UNITED STATES
NUCLEAR REGULATORY COMMISSION
OFFICE OF NUCLEAR REACTOR REGULATION
WASHINGTON, D.C. 20555

**NRC INFORMATION NOTICE NO. 89-87: DISABLING OF EMERGENCY DIESEL GENERATORS
BY THEIR NEUTRAL GROUND-FAULT PROTECTION
CIRCUITRY**

FIGURE 1

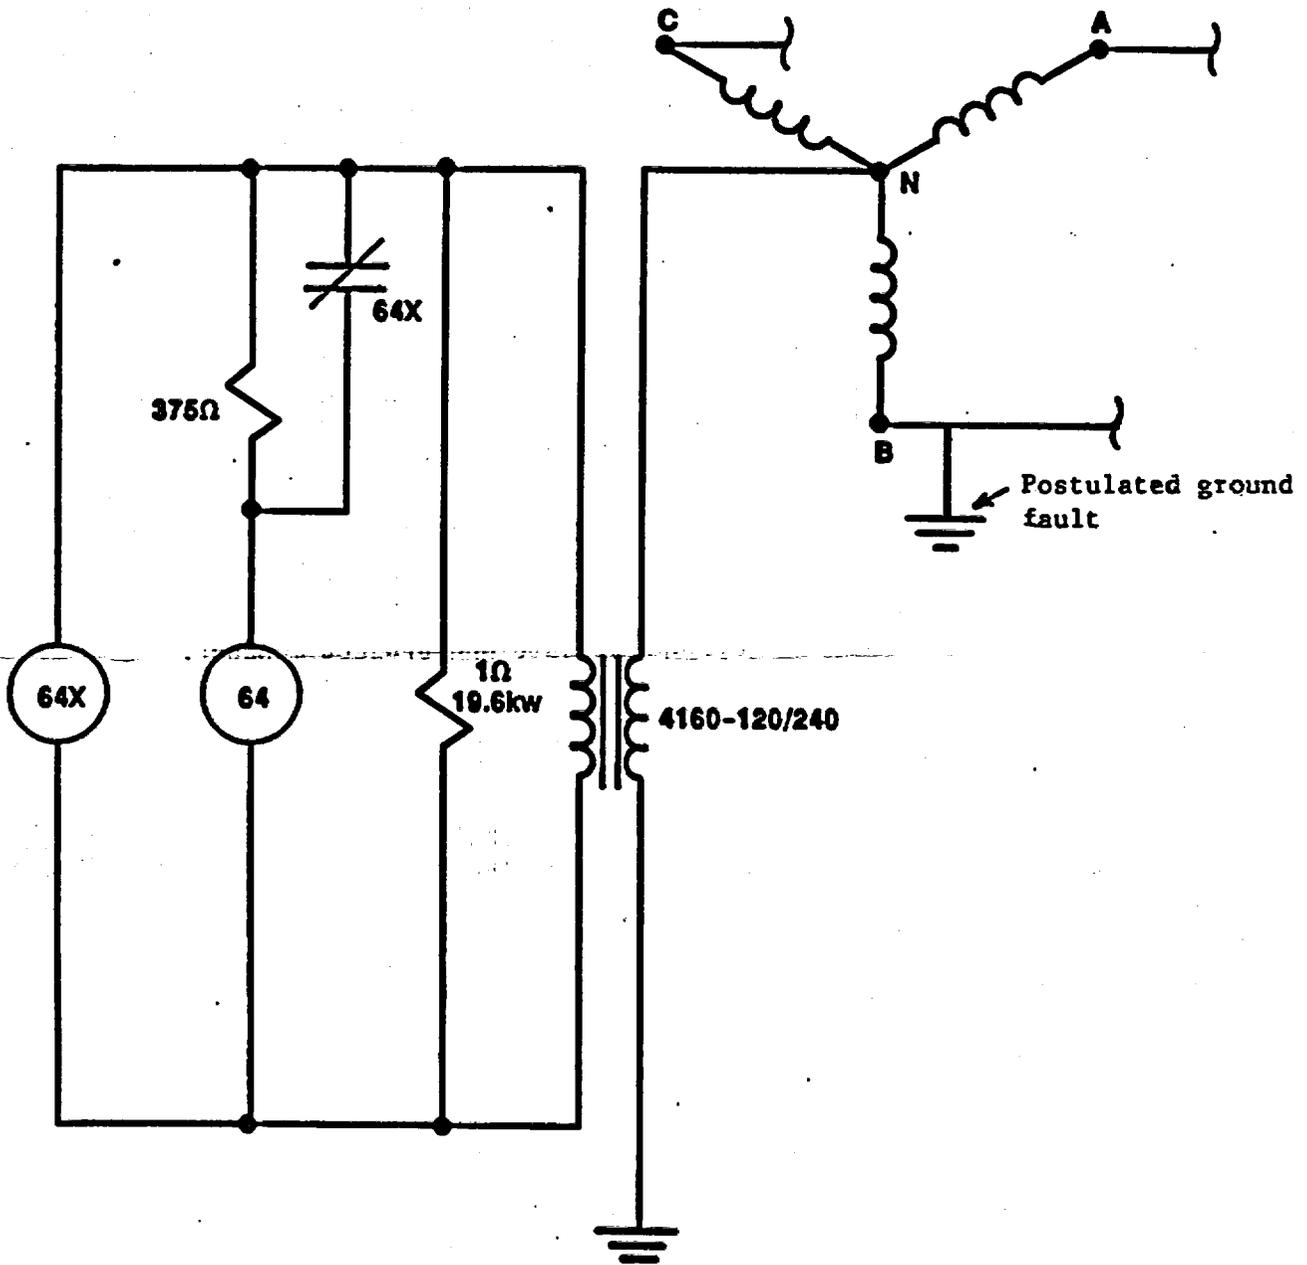
At Perry Unit 1, each emergency diesel generator was designed with a neutral ground circuit consisting of a high impedance path from the neutral to ground, which limits ground-fault current to no more than 2 amperes (see typical network in Figure 1). The purpose of providing this grounding path (in lieu of an ungrounded system) is to limit the buildup of high voltage stress during certain ground-fault conditions that could ultimately result in the breakdown of the insulation of such components as motors and cables. It also provides a convenient means of detecting a ground in the system so that a search can be made to eliminate the ground before a second ground occurs and causes a phase-to-phase fault.

Ground faults are detected by sensing the voltage that is developed in the emergency diesel generator grounding circuit whenever a ground fault exists in the electrical distribution system supplied by the emergency diesel generator. In the Perry design, a voltage sensing relay would initiate a trip of the corresponding emergency diesel generator whenever this voltage exceeded the relay's pickup value. This relay's contacts are bypassed by the automatic response to a loss-of-coolant accident. For non-LOCA events, however, a ground fault in any component, including non-Class 1E components, would have the undesirable result of shutting down the emergency diesel generator. This raises the concern that a seismic event or fire could have resulted in simultaneous ground faults in non-safety components supplied by all of the redundant emergency diesel generators. Action by the protection circuitry at Perry could then have shut down all of the emergency diesel generators, preventing them from performing their intended safety functions.

The Perry staff has temporarily disabled the neutral ground-fault relays to prevent them from shutting down the emergency diesel generators. Permanent modifications are planned to replace the ground-fault emergency diesel generator trip function with ground-fault alarms in the control room. These modifications will be supported by alarm response procedures requiring that the operators determine the location and safety significance of ground faults and take appropriate action.
